March 1, 2016

03188 Version 6

Safety Recall: Piston Pin Snap Ring InspectionSupersedes 16-017, dated February 26, 2016, to revise the information highlighted in **yellow**.**AFFECTED VEHICLES**

Year	Model	Trim	VIN Range
2016	Civic with 2.0L engine	ALL	Check the iN VIN status for eligibility

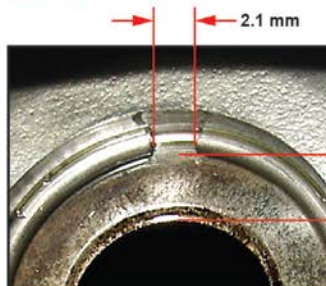
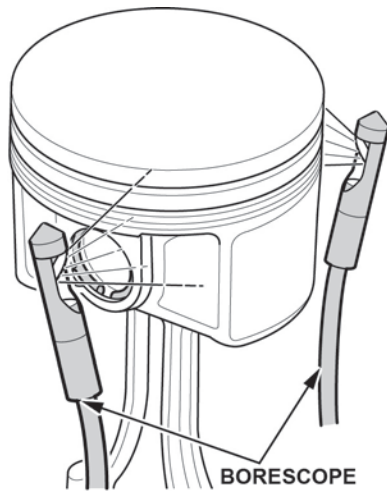
NOTE: You may notice a black mark on the snap ring and piston. This is a factory check mark and could be mistaken for the snap ring gap.
